**GM SERVICE AND PARTS OPERATIONS
DCS1409
URGENT - DISTRIBUTE IMMEDIATELY**

Subject: 04110 - Product Safety Recall
Passenger Side Power Sliding Door Interior Handle

Models: 1997-2005 Chevrolet Venture
1997-2004 Oldsmobile Silhouette
1997-1999 Pontiac Trans Sport
2000-2005 Pontiac Montana
Equipped with Passenger Side Power Sliding Door and
Second Row Bucket Seats or Captain's Chairs

SUBJECT: RIGHT-HAND POWER SLIDING DOOR INTERIOR HANDLE

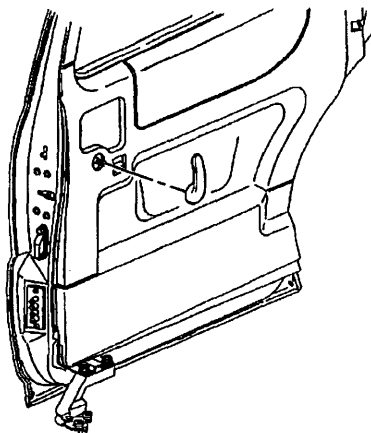
Although only the right-hand power sliding door handle requires replacement, dealers are to replace both rear door handles, if applicable, to keep the appearance consistent.

1. Using the J 42506, Door Handle Clip Remover, remove the inside door handle clip.

2. Remove the inside handle from the sliding door and discard.
3. Load the clip into the inside door handle with the open end facing up.
4. Align the new handle with the shaft on the sliding door.
5. Press firmly in order to seat the inside handle on the sliding door.
6. Repeat the steps for the other door, if applicable.
